Informal document No. 24
(85th GRSG, 21-24 October 2003
agenda item 2)

OICA PROPOSAL FOR DRAFT AMENDMENTS TO DOCUMENT
TRANS/WP.29/GRSG/2003/19
UN/ECE R52 (SMALL BUS CONSTRUCTION)

**"Figure 16b
Space for seated passengers behind a seat
and or/ a seat facing the gangway
(see paragraph 5.7.8.5.2) "**

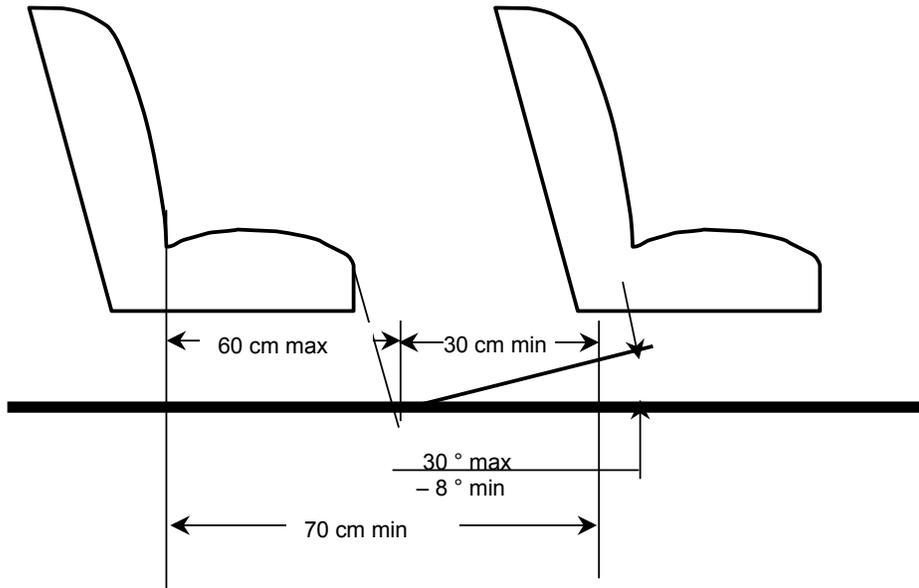
"5.7.8.5.2. For a seat behind a seat and/or a seat facing the gangway, a minimum clear foot space of at least 300 mm depth and a width **equal to that specified for a seat cushion in paragraph 5.7.8.2.1., reduced where appropriate by paragraphs 5.7.8.1.3.3 and 5.7.8.1.3.4**, shall be provided **as shown in Annex 3, figure 16b**. The local presence in this space of seat legs shall be permitted provided that adequate space remains for the passengers' feet. This foot space may partly be situated in and/or above the gangway but shall not create any obstruction when measuring the gangway-width in accordance with paragraph 5.7.5. **Intrusion of the seat belts and seat belt anchorages shall be allowed.**"

Insert a new drawing:

1. to clarify the interpretation of paragraph 5.7.8.5.1. and Annex 3 figure 16, which was intended not to impose any additional requirements on seat spacing but instead to determine the clear space between a passenger seat and a partition or other rigid structure other than a seat, and
2. to clarify that the foot space in front of each passenger seat may be so located such that parts of the foot space "intrude" into the gangway, either on the floor or above it. In any case, while measuring the gangway width with the respective testing gauge, the foot space shall not obstruct movement of the gauge.
